SUBDIVISION COMMITTEE
METROPOLITAN AREA PLANNING COMMISSION

STAFF REPORT
(One-Step Final Plat)

CASE NUMBER: S/D 99-7 - DAVIS - MOORE 13TH ADDITION

STAFF REPORT
(One-Step Final Plat, Deferred 2/4/99)

VICINITY MAP

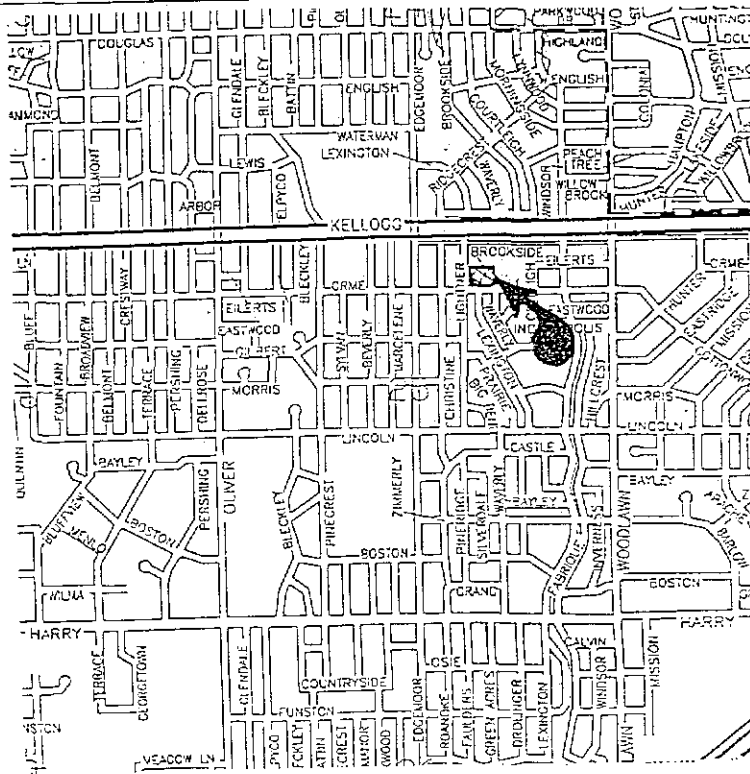
Increase to 20' Easement

- F. The plat depicts complete access control along Orme and two existing access points along Lightner. The plat's text shall note that the access controls are being dedicated to the "City of Wichita".

VICINITY MAP

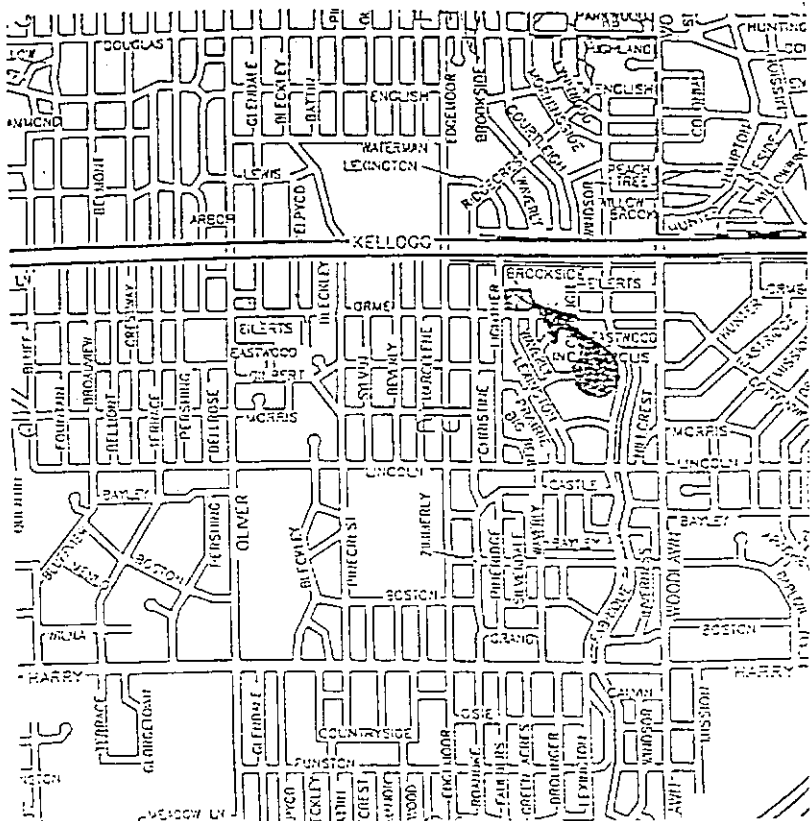
- F. The plat depicts complete access control along Orme and two existing access points along Lightner. The plat's text shall note that the access controls are being dedicated to the "City of Wichita".
